CITY OF VANCOUVER
POLICY REPORT
DEVELOPMENT AND BUILDING

TO: Vancouver City Council
FROM: Director of Planning
SUBJECT: CD-1 Rezoning - 335, 337 & 349 East 33rd Avenue

PROPOSED TOWNHOUSE DEVELOPMENT
 33TH AVENUE VANCOUVER, B.C.
 SPRINGBANK DEVELOPMENTS LIMITED

SITE PLAN /
GROUND FLOOR PLAN

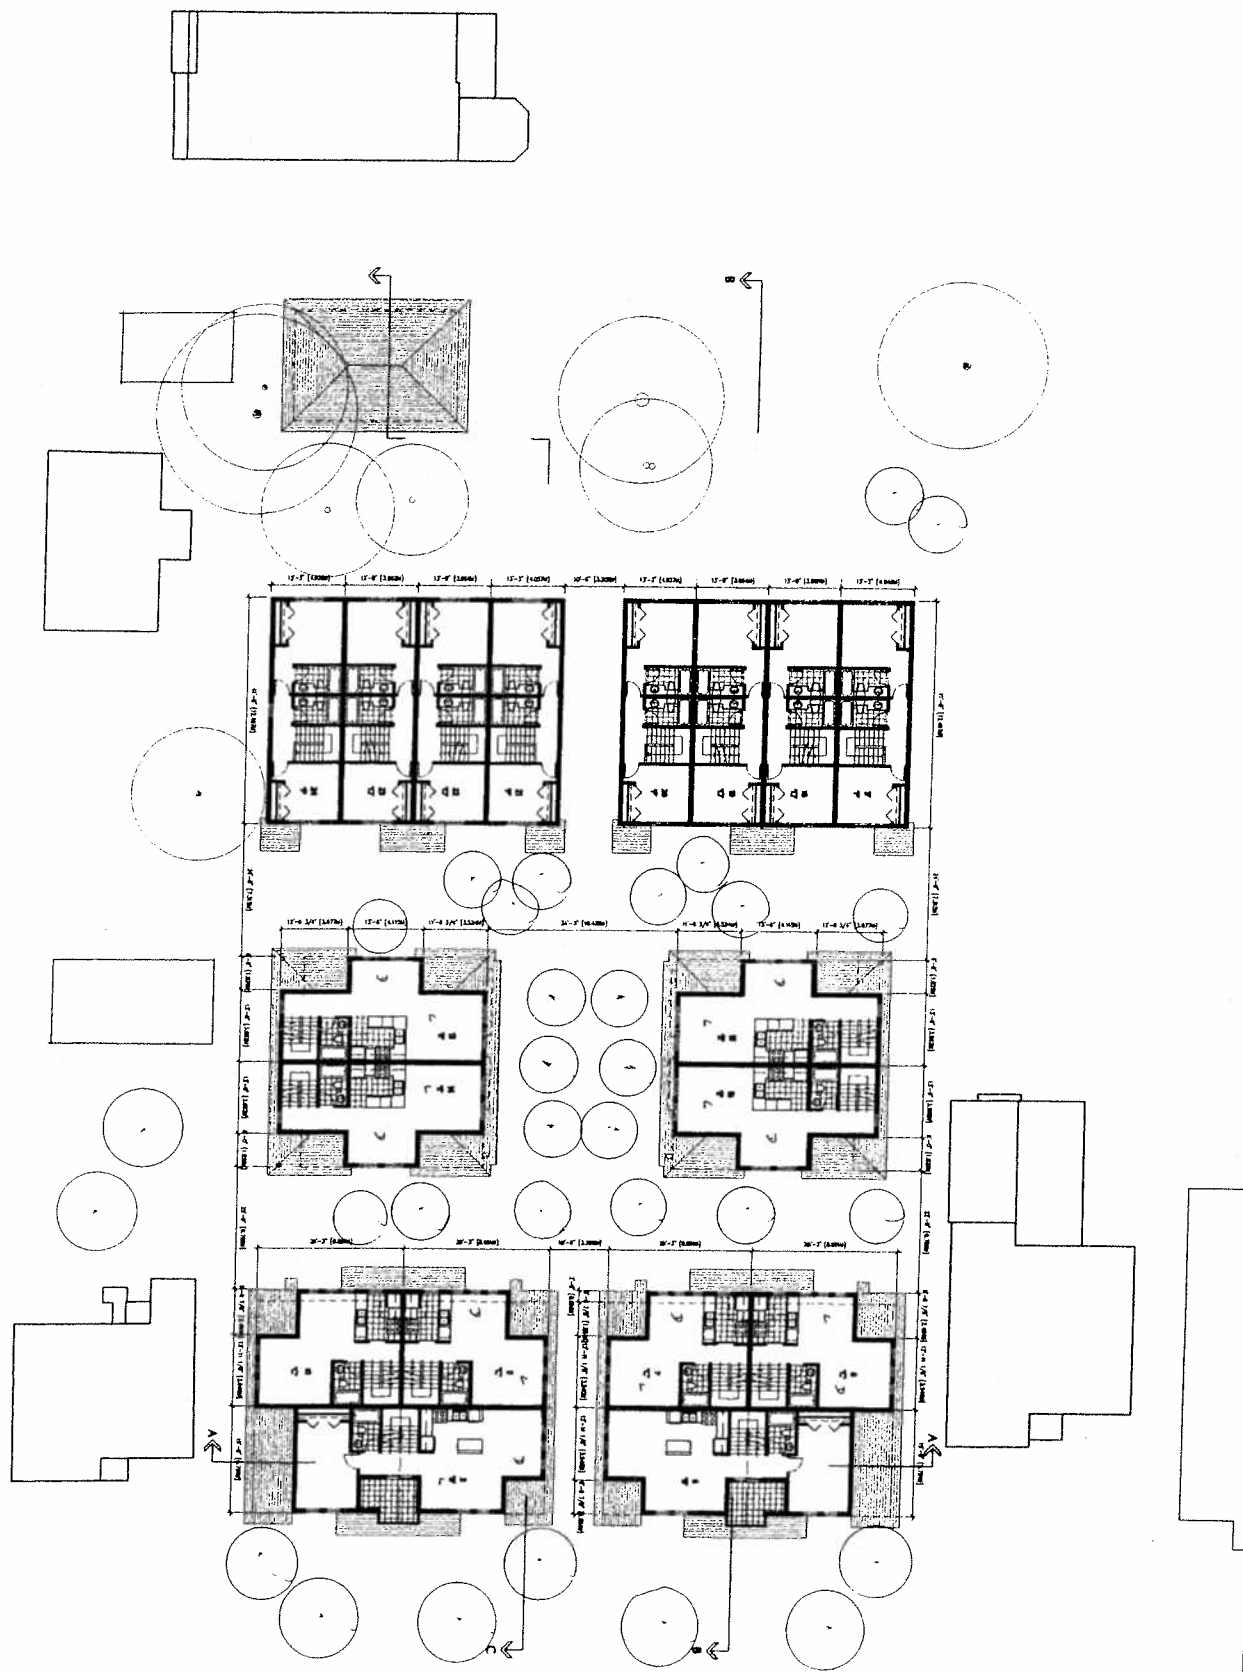
- (i) design development to improve neighbourliness by increasing the front and side yard setbacks and adding additional landscaping to all edges;

- (v) design development to improve on site pedestrian circulation and stair access to the parking level, increasing the circulation area at the top of the centre access stair and modifying the site plan to allow direct on-site access to the access stair, northeast corner of the site;

- (viii) design development to provide traditional residential - looking front yards bordering 33rd Avenue to complement the existing streetscape;

- (ix) design development to provide gated entry walks for the private rear yard patio areas to ensure direct pedestrian access into the common courtyard and walkway areas;
- (x) design development to provide a continuous level pedestrian path connecting the public sidewalk on 33rd Avenue to the rear of the site to ensure universal accessibility;
- (xi) provision of an ISA Arborist's written assessment commenting on the safe retention of neighbouring trees alongside construction as noted on the survey;

Note to Applicant: The front yard setback should be a minimum of 16 ft. (4.9 m) to allow for a better transition between the deeper setbacks of the adjacent buildings. The side yards should be a minimum of 6 ft. (1.8 m) to improve separation and privacy between neighbours. Additional planting in all setbacks, as well as along the lane edge and bordering the driveway ramp, will improve the quality of outdoor open space.

Note to Applicant: Enlarge pedestrian circulation area of the top of the centre stair without reducing or compromising landscaping or circulation area to the immediate north of the stair well. Stair at the northeast corner of the site needs to be accessible without leaving the site. Consider relocating stair and parking ramp to improve access and overall use of shared outdoor amenity space.

Note to Applicant: Each home should have a front walk leading directly from the public sidewalk to each front door through a well landscaped yard. The design of the front yards should encourage neighbourliness, with semi-private patios lightly screened by a variety of low and medium height plantings and a wide setback of open lawn at the public sidewalk.

FRONT BEAVTON 63RD AVENUE STREETSCAPE

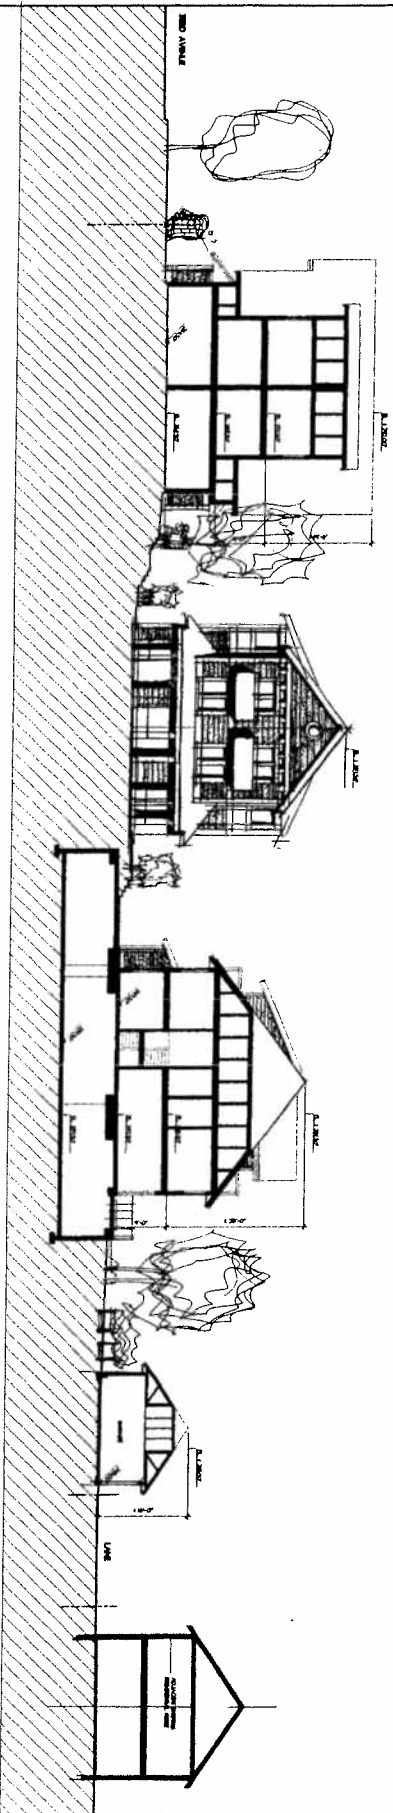
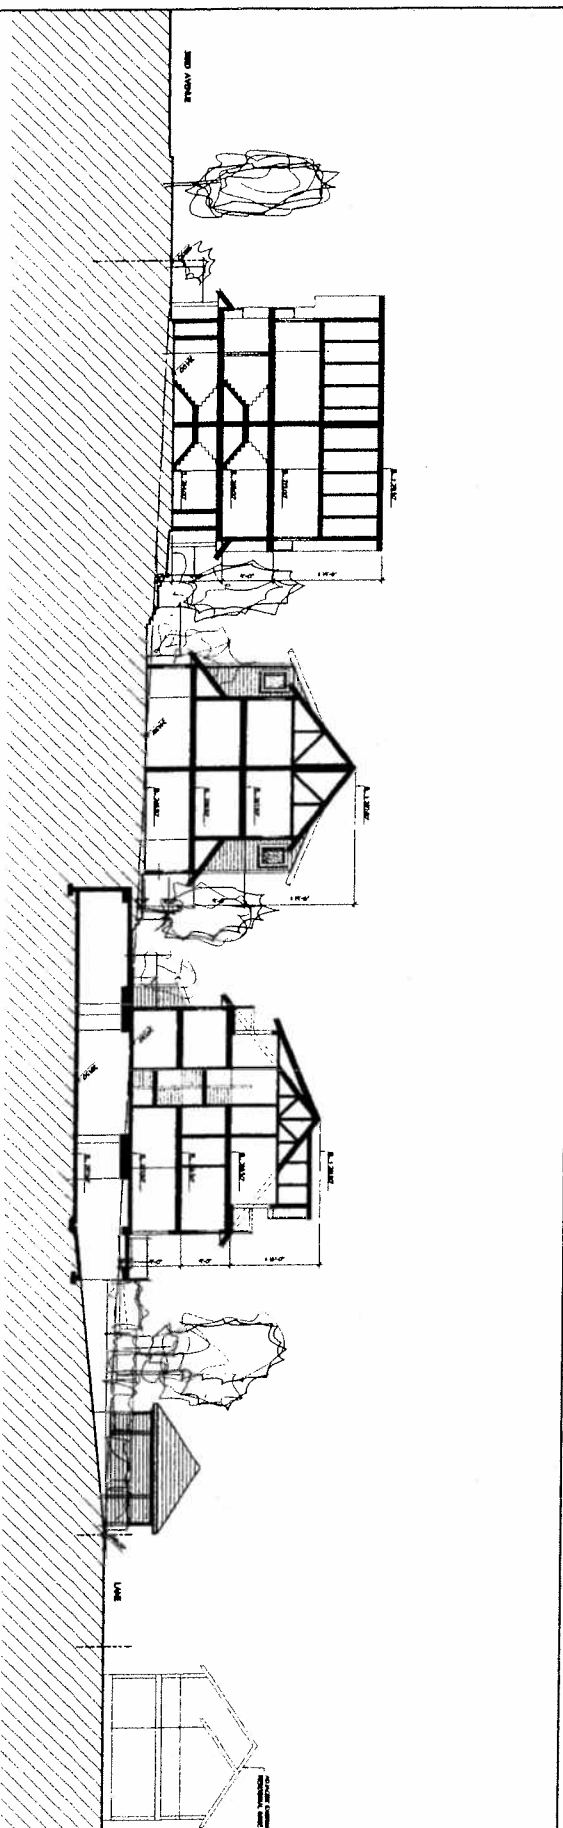
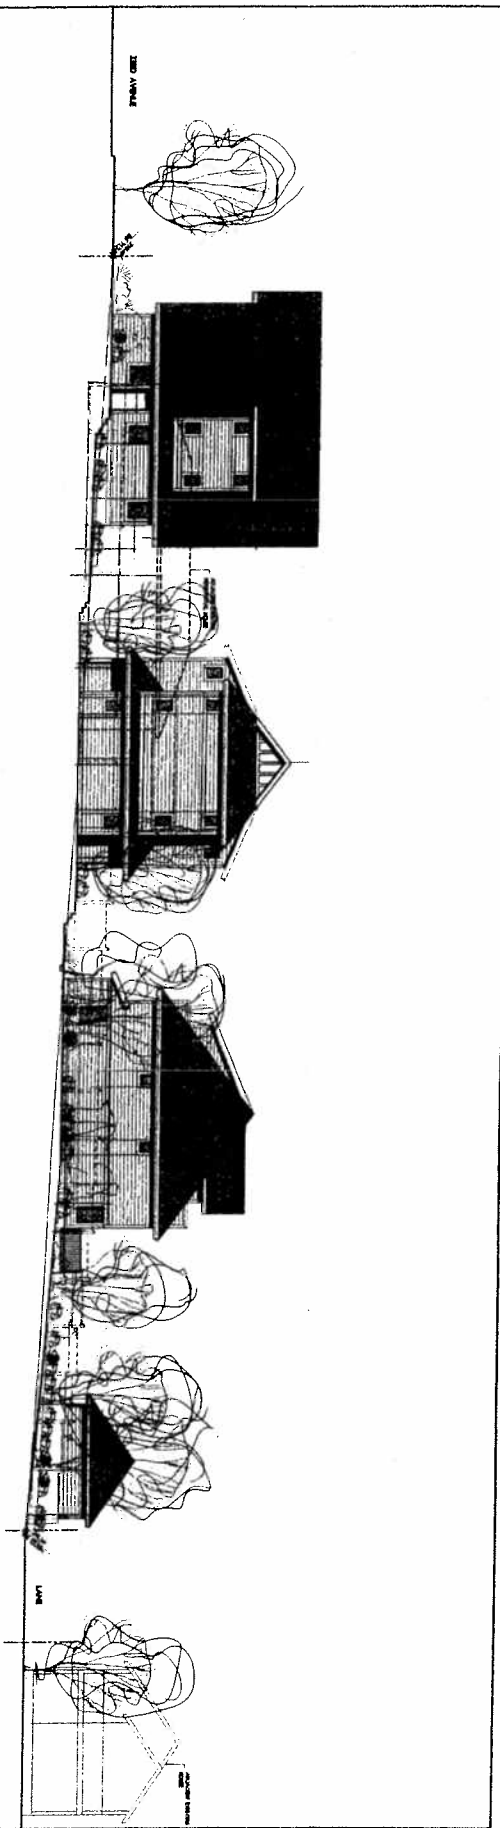
- (iii) design development to the roof form of the buildings facing 33rd Avenue, reducing the mass and scale and with better integration of the third floor into the roof form;

- (iv) design development to the building character, improving the consistency of roof form, building massing, material treatment and detail for all buildings;

Note to Applicant: The proposed gable roof form with a 1:1 pitch is supportable but needs to be smaller in size and more compatible with the scale and rhythm of the neighbourhood context.

Note to Applicant: The buildings should all appear to be of the same "family", with similar building massing and roof form, high quality materials and detail

embellishment, consistently applied to all building elevations. Proposed materials should have a dimensional thickness. Vinyl siding for example is not supported. Provide elevations of all building sides indicating proposed materials.
